**CRYSTAL RIVER UNIT 3  
PILOT PLANT AUDIT REPORT  
ANALYSES REQUIRED FOR THE RESPONSE  
TO GENERIC LETTER 2004-02  
AND GSI-191 RESOLUTION**

The following text is excerpted from the CR3 description of Engineering Change (EC) 58982R0 [69]. Figures 1, 2 and 3 are drawings representing the major features of the proposed new sump design. These proposed changes represented a significant part of the audit review:

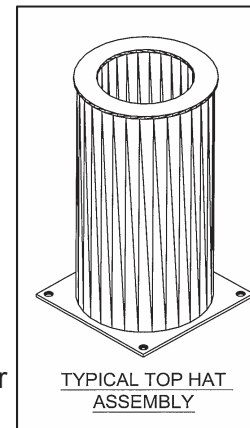
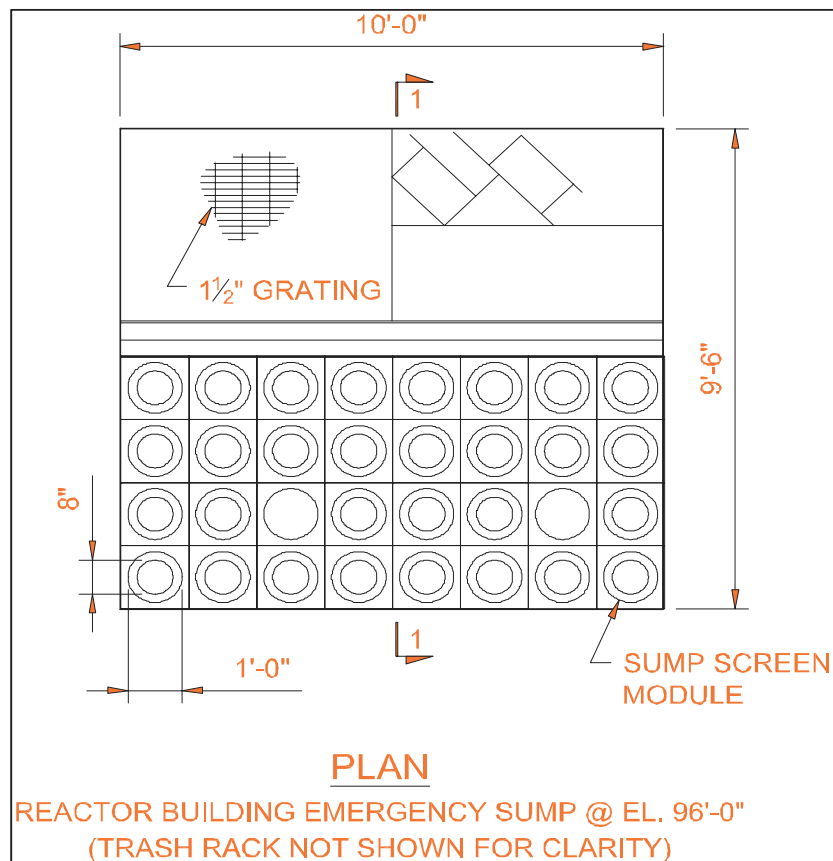
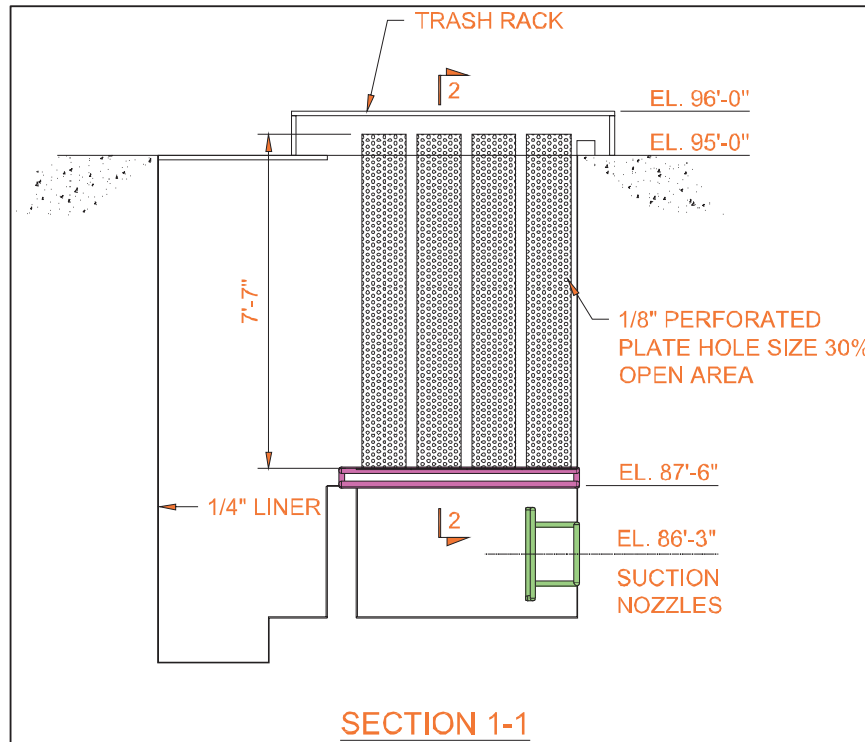
The licensee did not provide any scaled test data to justify the conservatism of the uniform debris bed distribution assumption. Based on the flow field within the top-hat strainer array, one could assume a non-uniform bed formation. The licensee should justify the assumption technically.

The NRC staff has concluded that the licensee's overall screen modification approach appears reasonable. However, because the adequacy of the new screen design and other proposed modifications is highly dependent on the acceptability of the various analyses that establish the screen design (i.e., debris generation, debris transport, debris accumulation, and head loss), further design changes could be necessary as the licensee finalizes the various ongoing aspects of the sump performance evaluation. The licensee stated that it will revise the 10 CFR 50.59 evaluation once the design is finalized and will revise the current licensing basis at that time.
